SCHWEIZER SERVICE NOTICE

NOTICE NO. N-217
DATE: 29 JAN 1988
PAGE 1 of 5

SUBJECT: IDENTIFICATION OF CENTER FRAME AFT CLUSTER FITTINGS; INSTALLATION OF 269A4646-19 SUPPORT STRUT PLACARDS.

FIGURE 1. IDENTIFICATION OF CLUSTER FITTING AND PLACARD INSTALLATION (TYPICAL BOTH SIDES)

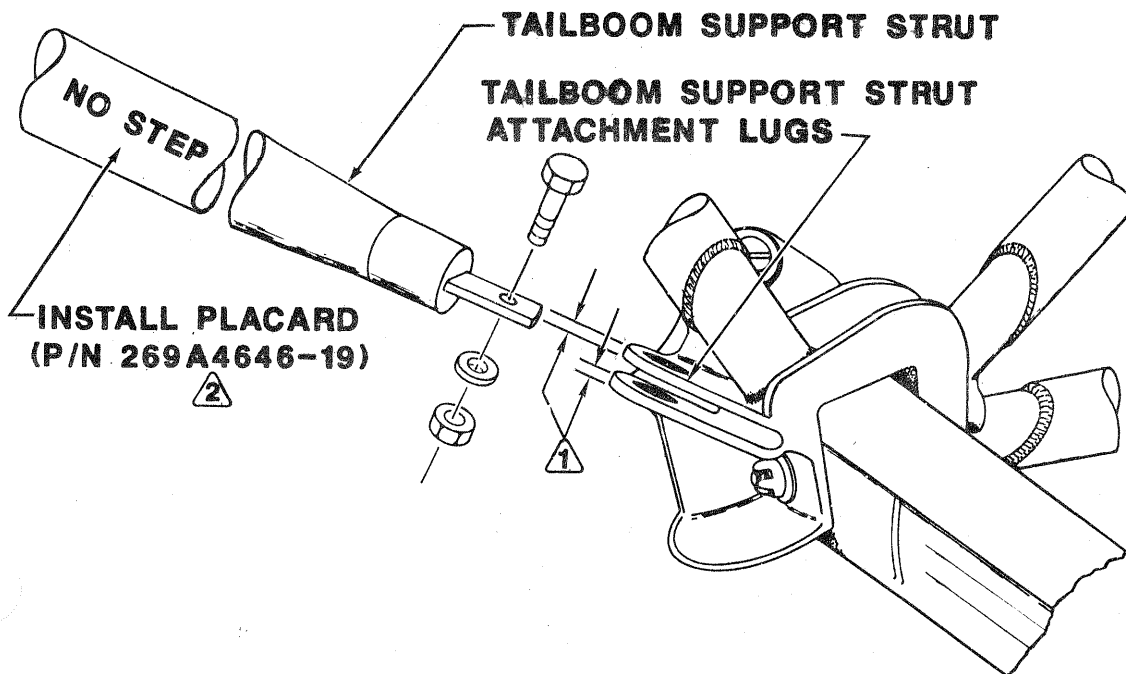
- a. Using a suitable measuring device, measure the thickness of the cluster fitting attachment lugs for tailboom support strut. (Refer to Figure 1.)

The tailboom strut attachment clevis on BSC fittings (269A2234 (LH) and 269A2235 (RH)) will have a dimensional thickness of 0.070 to 0.100-inch. The attachment lugs on the -3 fittings (269A2234-3 and 269A2235-3) will have a thickness of 0.115 to 0.155-inch.

- (1) Thoroughly clean upper surface of support strut where placard is to be installed. (Refer to Figure 1.)
 - (2) Peel protective backing off from placard and install placard on strut.
 - (3) Repeat steps (1) and (2) for other strut.
- b. Record Compliance with Part II of this Service Information Notice in Compliance Record of Helicopter Log Book.

- ① LUG THICKNESS WILL BE 0.070 TO 0.100 INCH ON BASIC FITTINGS (P/N 269A2234 AND 269A2235). ALL -3 FITTINGS (P/N 269A2234-3 AND 269A2235-3) WILL HAVE A LUG THICKNESS OF 0.115 TO 0.155 INCH. (REFER TO PART I.)**

- ② INSTALL PLACARD ON STRUT (IN CLEAR VIEW) AT APPROXIMATELY 8 TO 10 INCHES FROM CENTER LINE OF STRUT LOWER END FITTING ATTACHMENT HOLE (BOTH STRUTS). (REFER TO PART II.)**
